Please file and use this manual together with the Service Manual for Model No. RX-DS520, Order No : MD9510125C1.

Note: • This Simplified Service Manual is provided to indicate the main differences between the original model no. RX-DS520(P) and the subsequent model RX-DS515 (P/PC).

RX-DS515

Cabinet Parts Differences

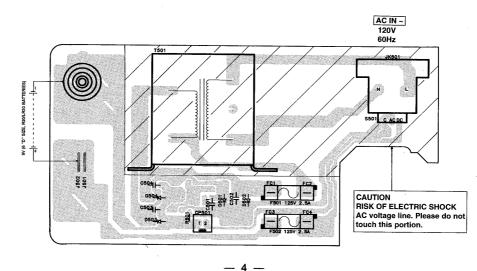
Note: These differences apply to 'Operation Checks and Main Component Replacement Procedures' and "Cabinet Parts Location"

Printed Circuit Board

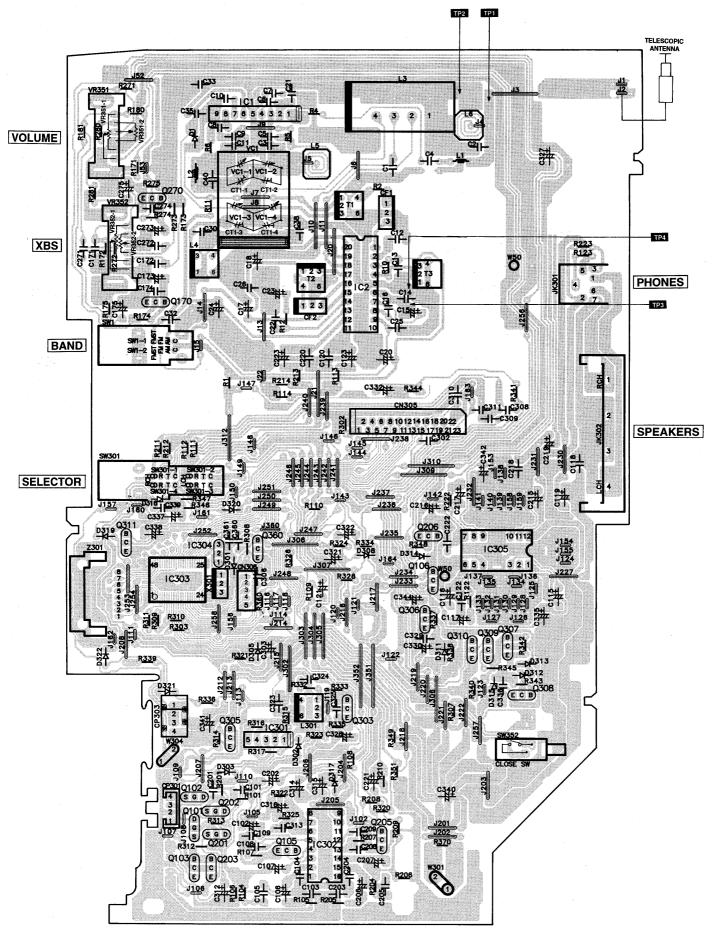
D G.E.Q. P.C.B. (REPX0099) ... DELETED

OPERATIONAL P.C.B. (REPX0098 ==> REPX0098B)

F SWITCH P.C.B. (REPX0098 ==> REPX0098B)

C POWER P.C.B. (REPX0100A) ... For PC area only

B MAIN P.C.B. (REPX0098 ==> REPX0098B)

Schematic Diagram

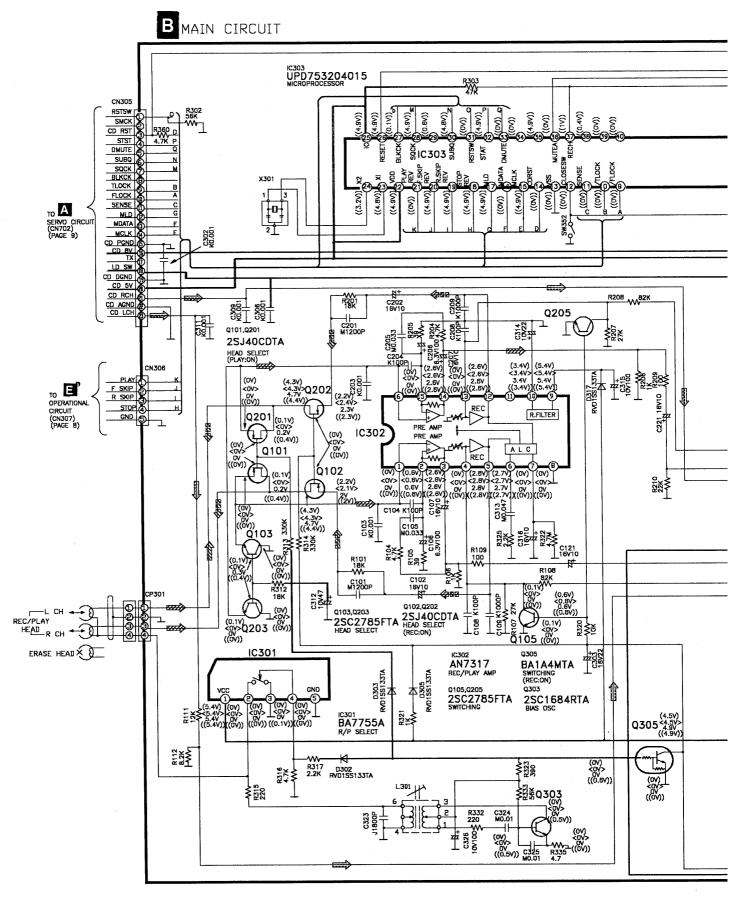
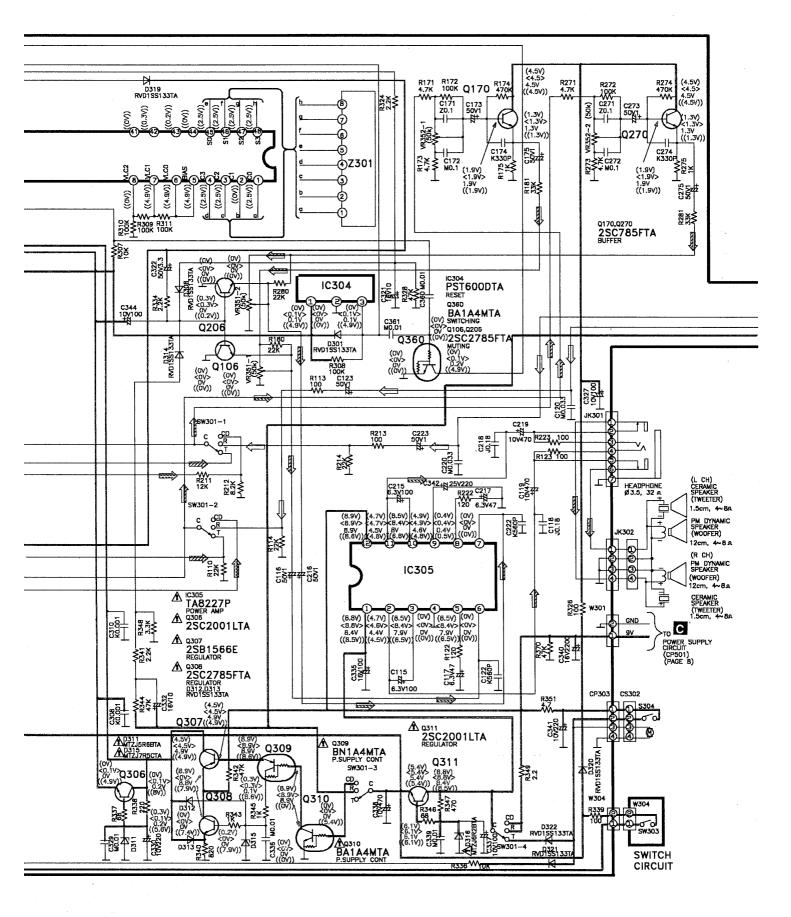
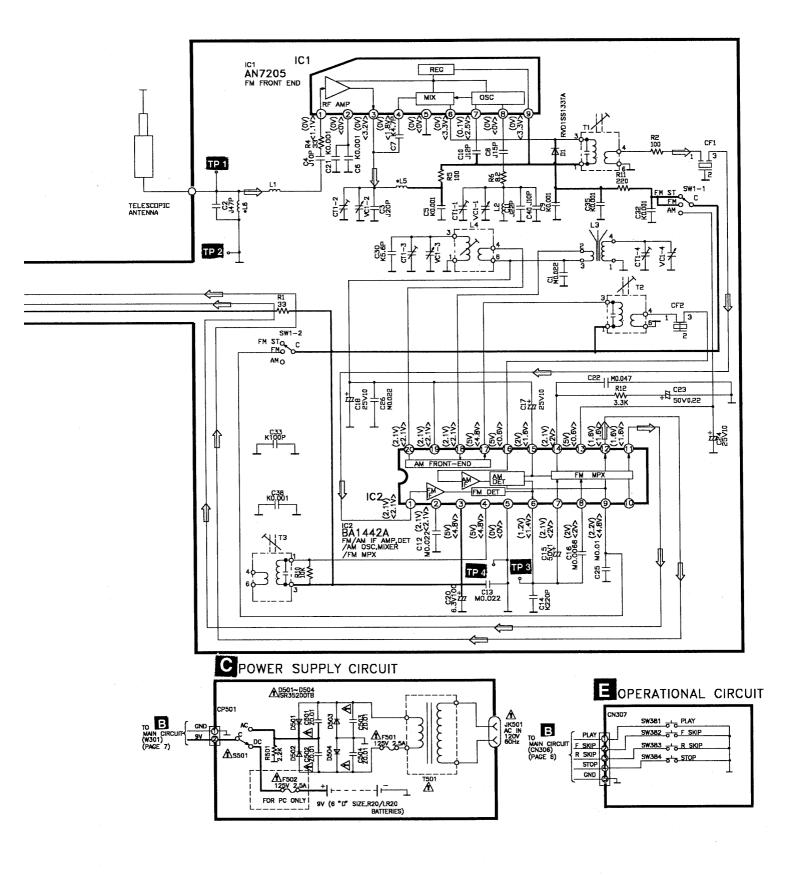
D G.E.Q. CIRCUIT ... DELETED
